STAFF REPORT

Case #21-09: **Site Plan Review**

Case #21-10: **Special Permit**
563 County Street
Map: 58 Lot: 259

The former Holy Family High School.

Signage

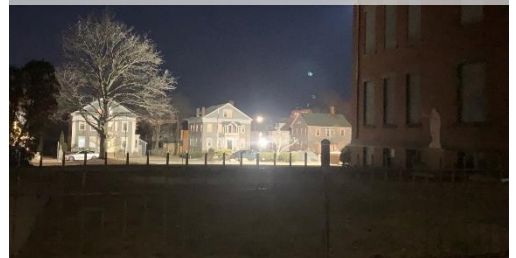
A standard handicapped parking sign is proposed for the handicapped accessible parking space. No other signage is proposed.
